ENGINEERING BULLETIN

Grain Cart Directional Downspout Hydraulic Orifice Update

The following procedure will install a speed regulating orifice in order to improve the operation of the directional downspout.

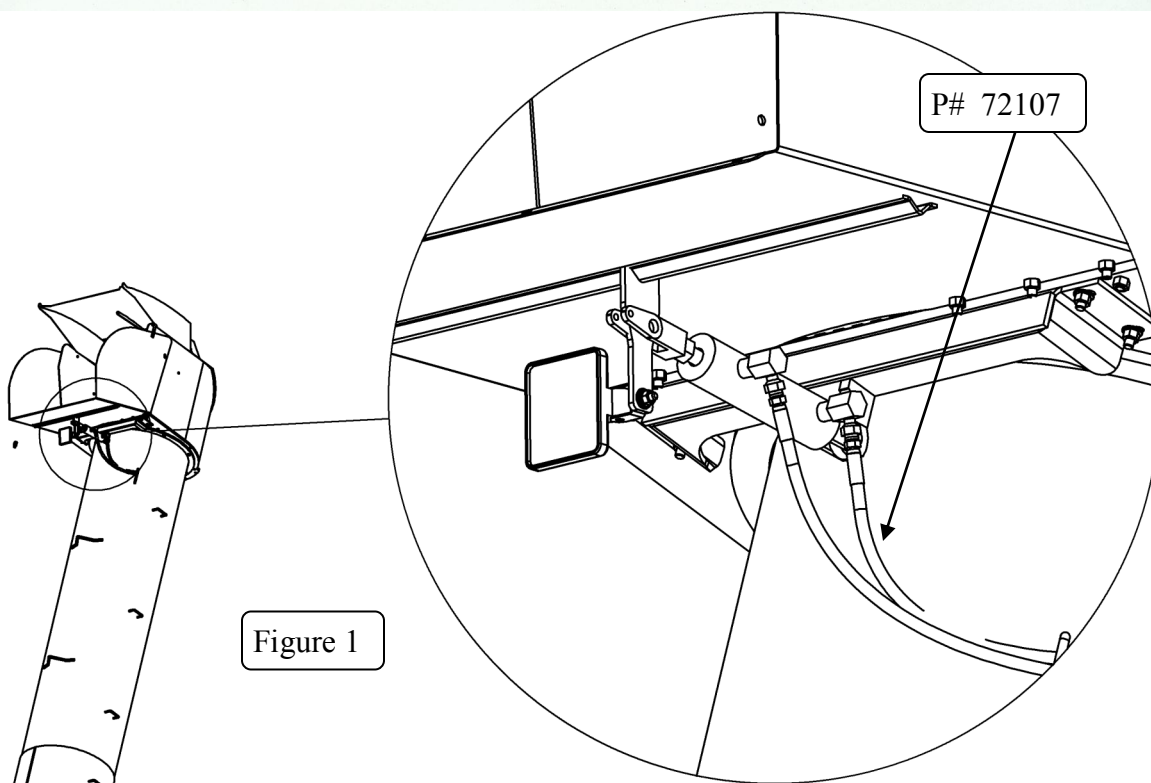
Remove hydraulic hose P# 72107. See Figure 1.

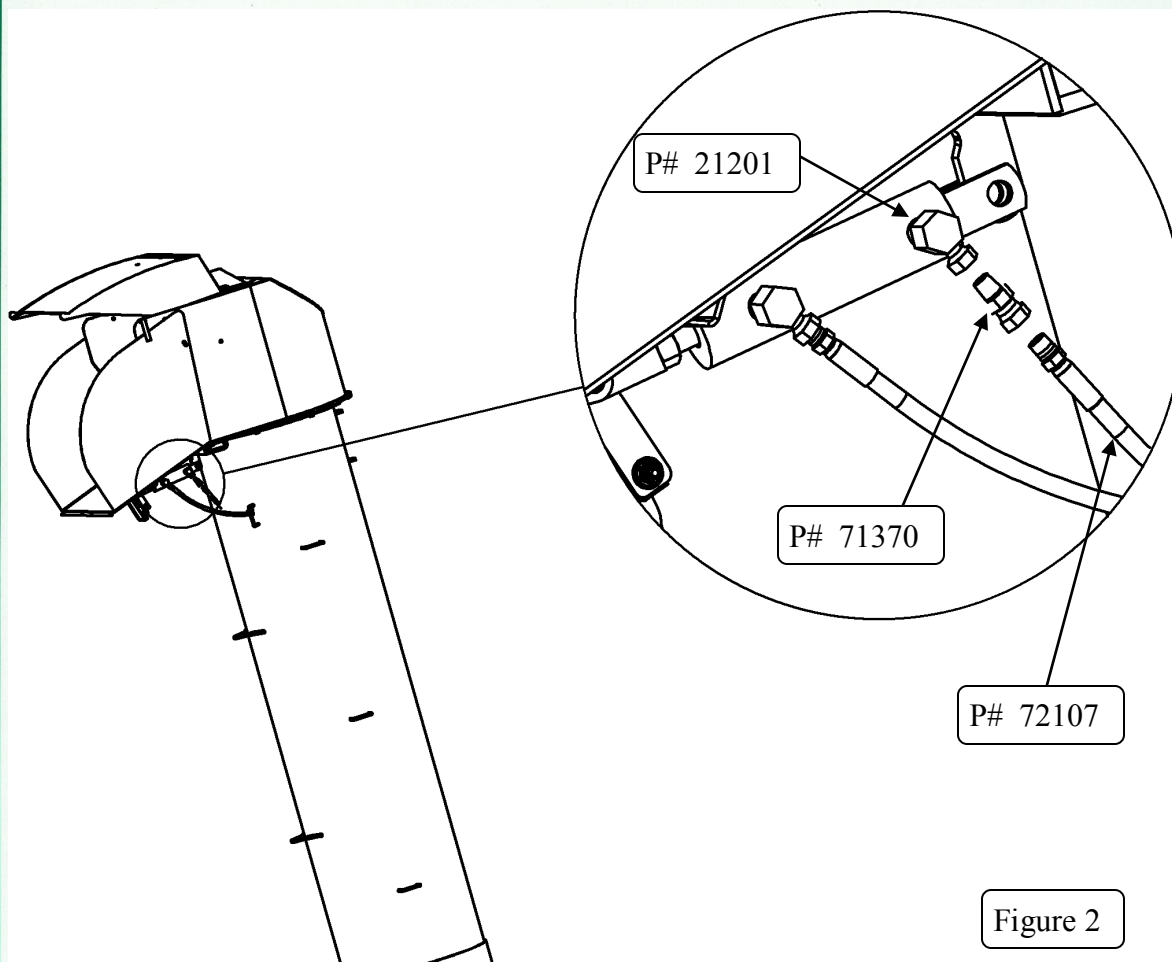
Install hydraulic orifice P# 71370 onto hydraulic fitting P# 21201. Reinstall hydraulic hose P# 72107. Tighten all fittings. See Figure 2.
